# HISTORIC AND DESIGN REVIEW COMMISSION

**HDRC CASE NO:** 2019-124  
**ADDRESS:** 517 LABOR  
**LEGAL DESCRIPTION:** NCB 926 BLK 4 LOT S IRR 79.3FT OF N IRR 93.3FT OF 29 & N TRI 25FT OF 30  
**ZONING:** C-2,H  
**CITY COUNCIL DIST.:** 1  
**DISTRICT:** Lavaca Historic District  
**APPLICANT:** Cindy Castro  
**OWNER:** Guadalupe Castro  
**TYPE OF WORK:** Demolition of primary structure with new construction of a Tuff shed  
**APPLICATION RECEIVED:** January 03, 2019  
**60-DAY REVIEW:** March 04, 2019; 30 day decision period – April 3, 2019  
**CASE MANAGER:** Stephanie Phillips  
**REQUEST:**

1. Demolish the historic structure located at 517 Labor.
2. Construct a 1-story Tuff Shed structure to serve as a primary residential structure totaling approximately 288 square feet.

Premier Pro Tall Barn - 12' wide by 24' long

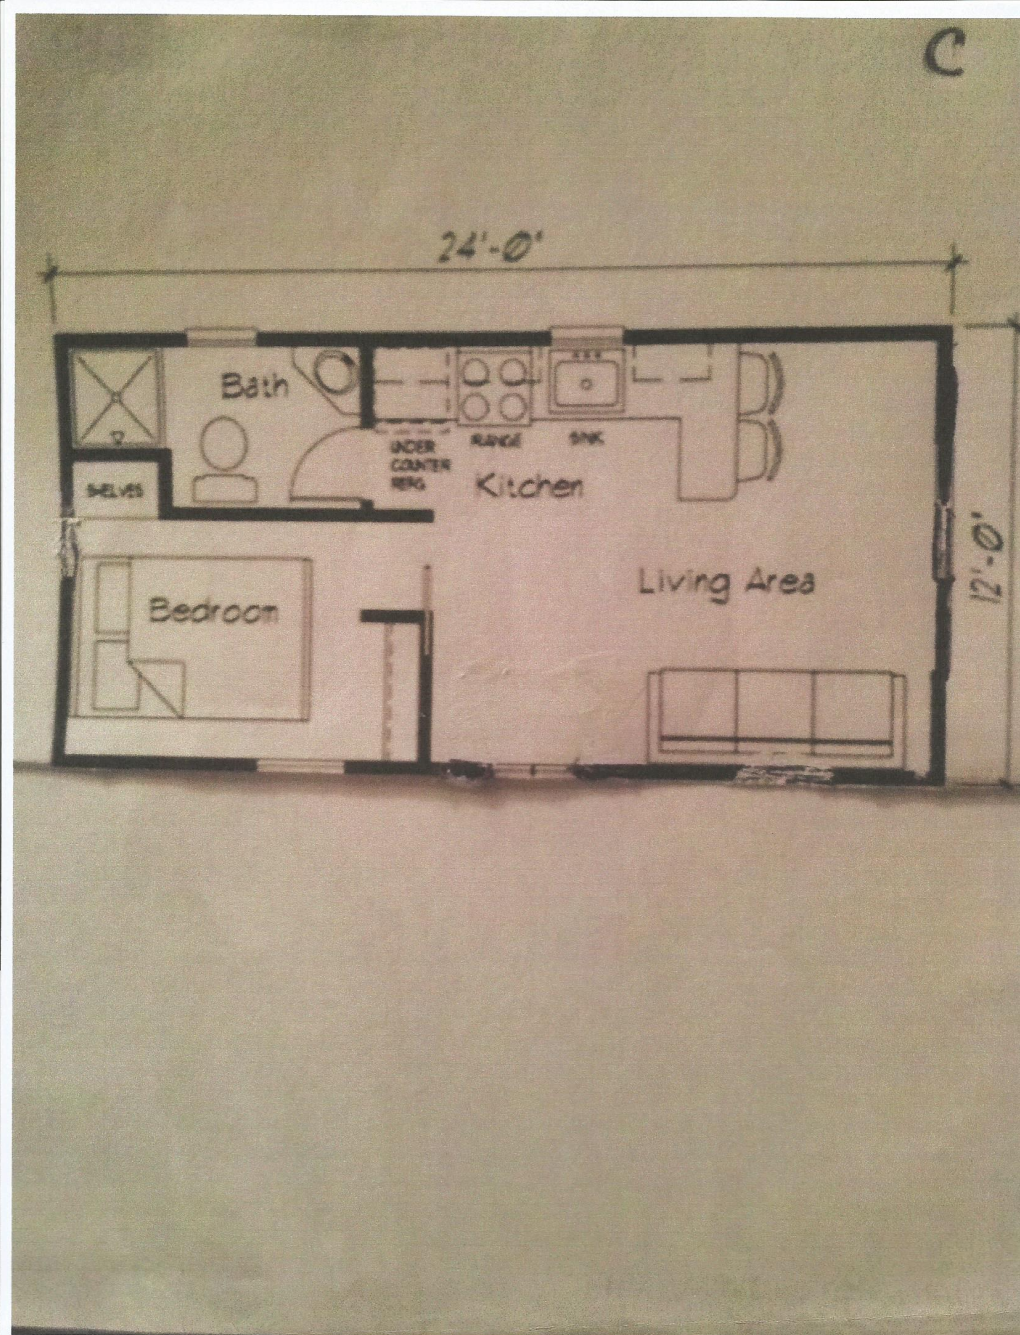
- 2d. FOOTPRINT – The applicant has proposed a footprint of approximately 288 square feet. According to the Historic Design Guidelines, new construction should be consistent with adjacent historic buildings in terms of the building to lot ratio. The existing structure is approximately 750 square feet, which is consistent with the historic development pattern of the district. Primary structures with footprints smaller than 750 square feet are rare in the Lavaca Historic District. Staff does not find 288 square feet to be an appropriate footprint.

- 2f. ROOF FORM – The applicant has proposed a roof form that is similar to a traditional gambrel barn roof. Gambrel roof forms are not found within the Lavaca Historic District and rarely found in residential historic districts in San Antonio or the greater Central Texas region. Staff does not find the form consistent with the Guidelines.

- 2h. LOT COVERAGE – The building footprint for new construction should be no more than fifty (50) percent of the size of total lot area. The applicant's proposed building footprint is generally consistent with Guidelines for New Construction 2.D.i., but as noted in finding 2d, the footprint of the structure is significantly smaller than existing historic primary structures in the district.

- 2i. MATERIALS – The applicant has noted the use of standard Tuff Shed materials, including composite siding, shingle roofing, and composite skirting. While staff finds that composite materials may be appropriate for new construction, the manner in which these materials are used in the design is not appropriate.

- 2j. WINDOW MATERIALS – As presently proposed, the window materials and proportions are not consistent with the Historic Design Guidelines or the OHP window policy document. The applicant should ensure that the proposed windows are one over one configuration and feature meeting rails that are no taller than 1.25" and stiles no wider than 2.25". White manufacturer's color is not allowed, and color selection must be presented to staff. There should be a minimum of two inches in depth between the front face of the window trim and the front face of the top window sash. This must be accomplished by recessing the window sufficiently within the opening or with the installation of additional window trim to add thickness. Window trim must feature traditional dimensions and an architecturally appropriate sill detail. Window track components must be painted to match the window trim or concealed by a wood window screen set within the opening.

2. Staff does not recommend approval of request item #2, the construction of a 1-story residential Tuff Shed structure, based on findings 2a through 2l.
